**Interstate 5 North Coast Corridor
Project**

PRELIMINARY
NOISE ABATEMENT DECISION REPORT
INTERSTATE 5 NORTH COAST CORRIDOR PROJECT

Addendum
For Noise Barriers S686 b/c, S863, and S603 Option 1
August 27, 2013

SOUND WALL S603 (OPTION 1)
 STATION 597+80 TO 608+15
 LENGTH = 1,047 m (3,435 ft)
 MAX HEIGHT = 3.7 m (12 ft)

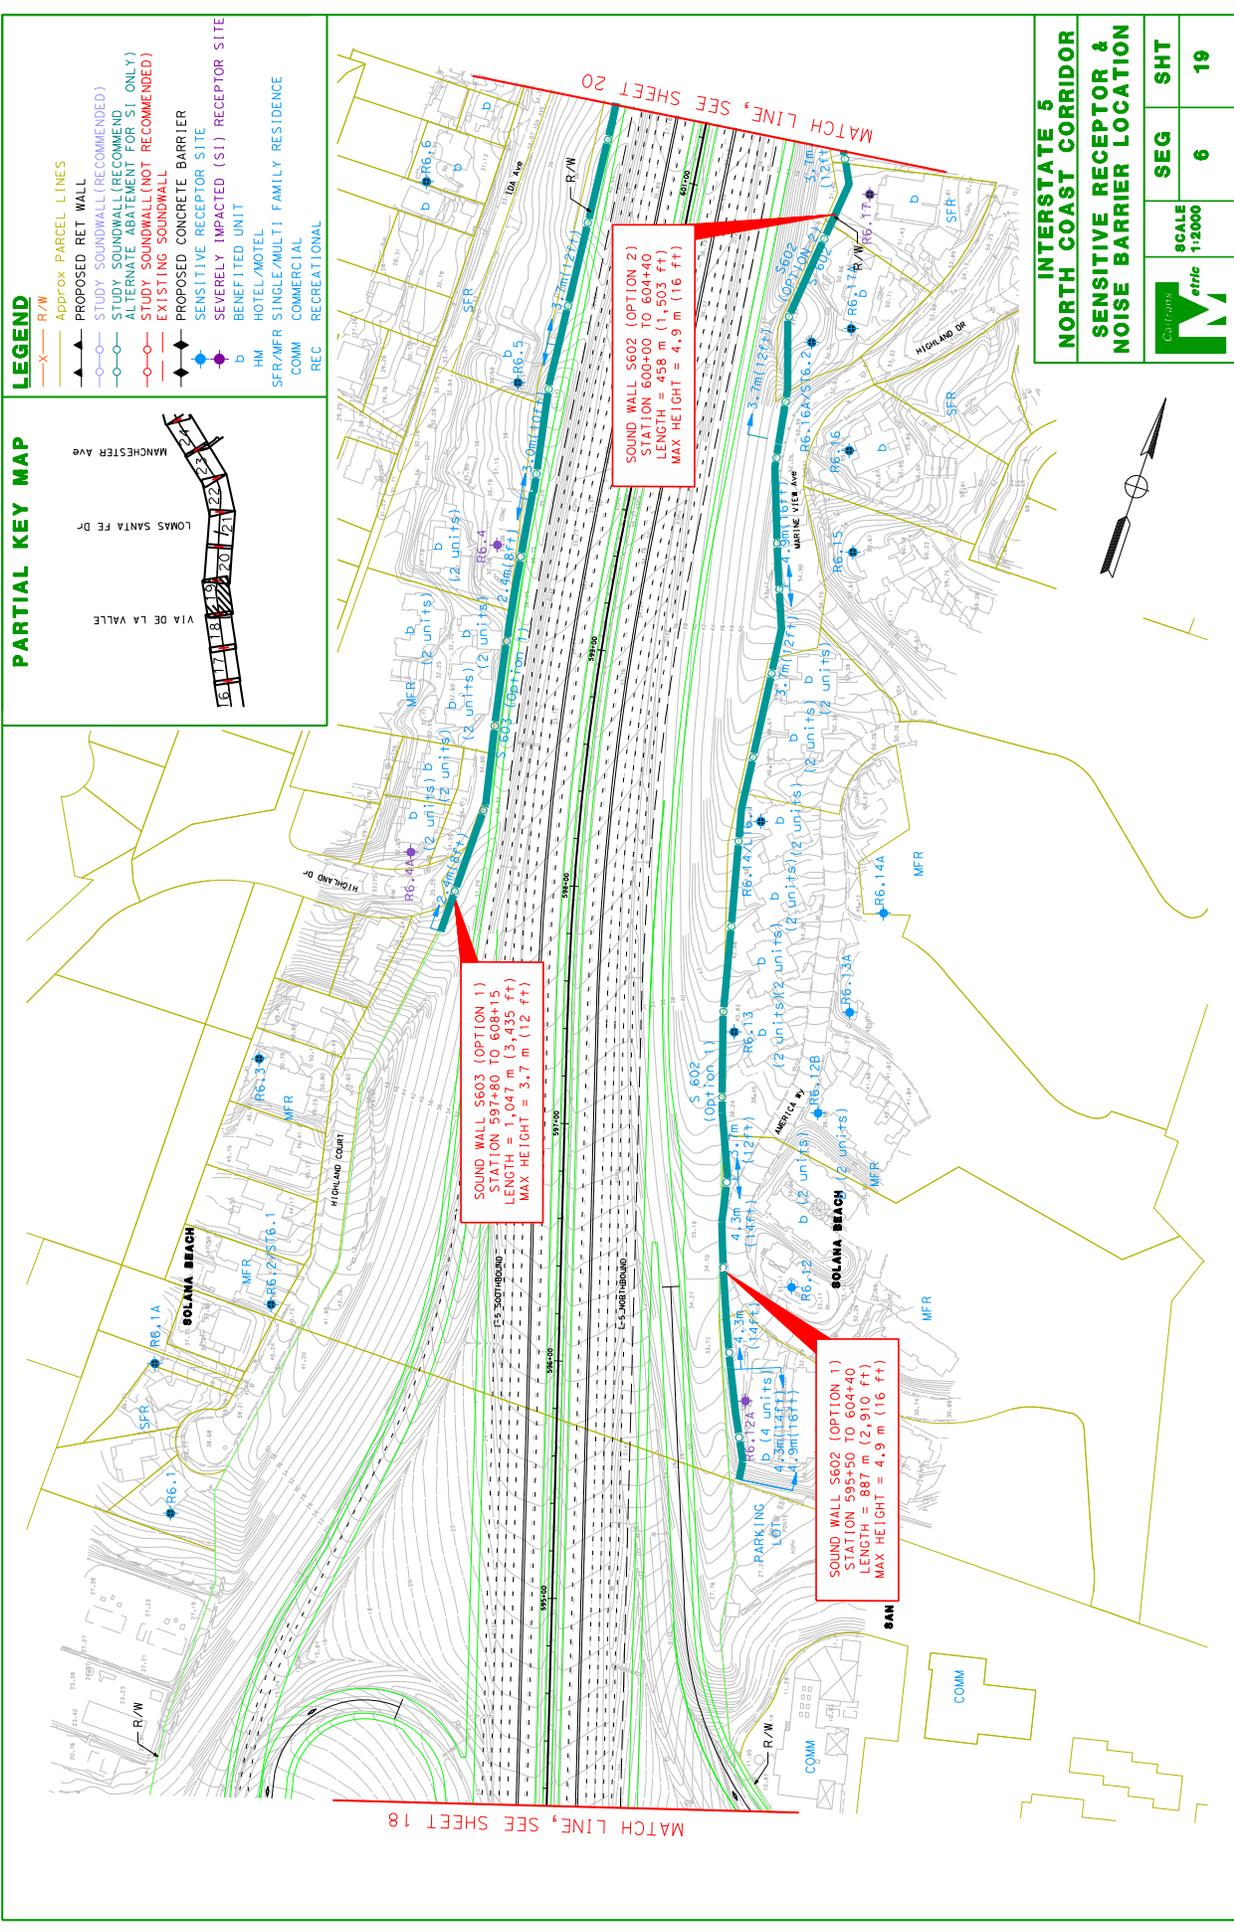
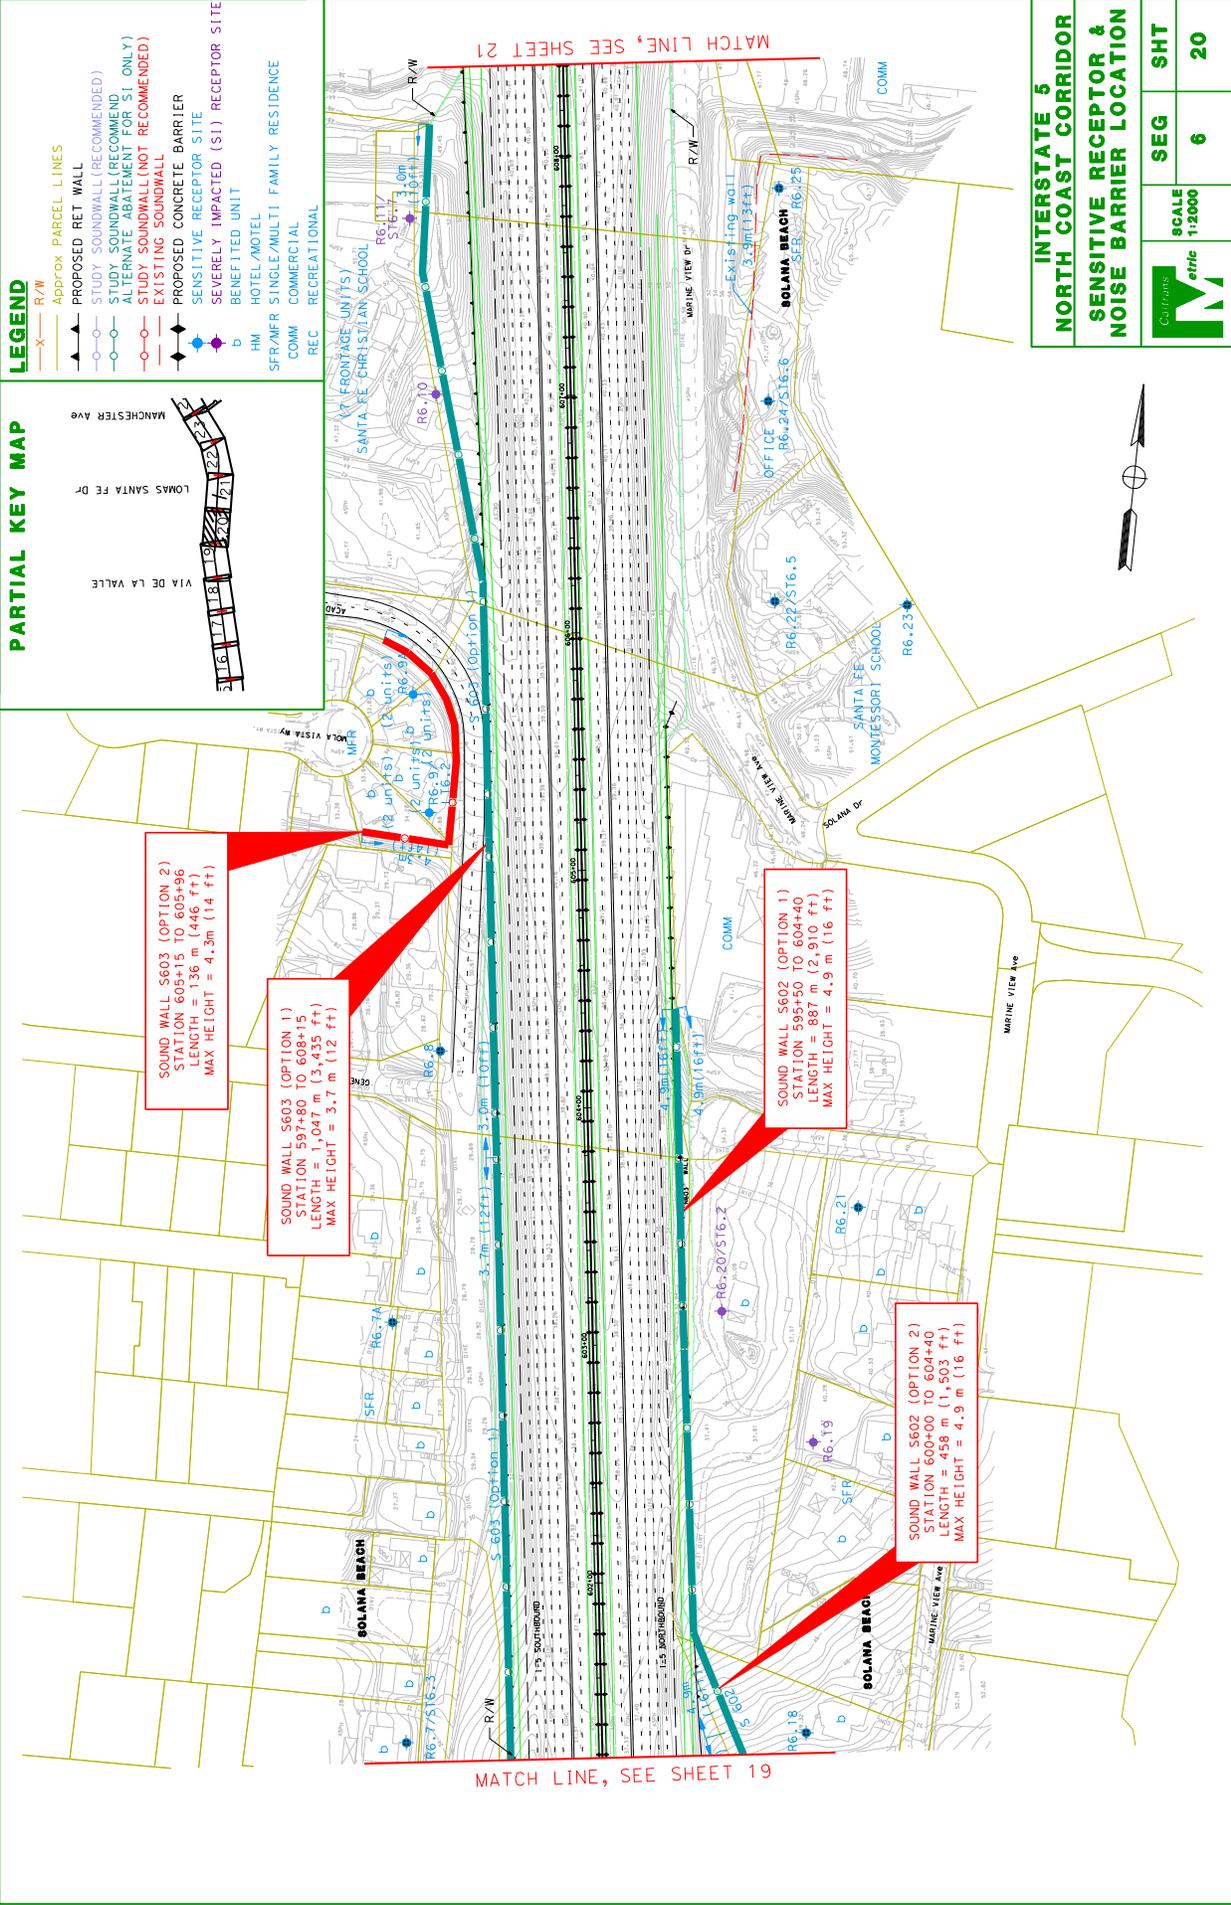
Noise barrier S603 Option 1 would be located along the southbound side of I-5, north of Via de la Valle. The noise barrier would provide a feasible reduction in highway traffic noise for 14 single-family and 20 multi-family residences, as well as St. Leo's Head Start Pre School and Santa Fe Christian School all represented by Receptors R6.4A and R6.4 to R6.11. The estimated construction cost of S603 (Option 1) including all easement costs, would be less than the reasonable cost allowance, and so would be reasonable. A solid noise barrier, however, would have the potential to block scenic coastal views for freeway motorists protected under the Coastal Act. For purposes of the noise analysis, the solid noise barrier has been identified in Table 3.15.13 of the Final EIR/EIS. For that reason, it is now recommended to create a gap in the noise barrier S603 (Option 1) for maintaining coastal views.

Noise Barrier S603A and S603B (Option 1A)

Noise barriers S603A and S603B will divide the noise barrier from Option 1 into two noise barriers with a gap that starts at station 601+00 and ends at station 604+80.

Noise barrier S603A would provide a feasible reduction in highway traffic noise for 12 multi-family residences represented by Receptors R6.4A and R6.4 and one single-family represented by R6.5. Noise barrier S603B would provide a feasible reduction in highway traffic noise for four multi-family residences, represented by Receptors R6.9A as well as Santa Fe Christian School represented by R6.10, and R6.11 which counts for seven Frequent Use Areas. Receptors R6.6 through R6.9 would not receive feasible noise reduction with gap in the noise barrier. The estimated construction cost of both S603A and S603B including all easement costs, would exceed the reasonable cost allowance. Since there are severely impacted receptors, including R6.10 and R.6.11 -representing Santa Fe Christian School- that must be abated for, the PDT decided to recommend construction of both S603A and S603B.

As shown in Segment 6, Revised Sheets 19 and 20, of this NADR, noise barriers 603A and B (Option 1A) would be located on Caltrans right-of-way along the southbound side of I-5, north of Via de la Valle.

Construction of noise barrier S603A is feasible but not reasonable due to the estimated construction cost being higher than the total cost allowance for noise barrier S603A. However, since there are severely impacted receptors that must be abated for, the PDT made the determination to construct this noise barrier.

Construction of noise barrier S603B is feasible but not reasonable due to the estimated construction cost being higher than the total cost allowance for noise barrier S603B. However, since there are severely impacted receptors that must be abated for, the PDT made the determination to construct the noise barrier.
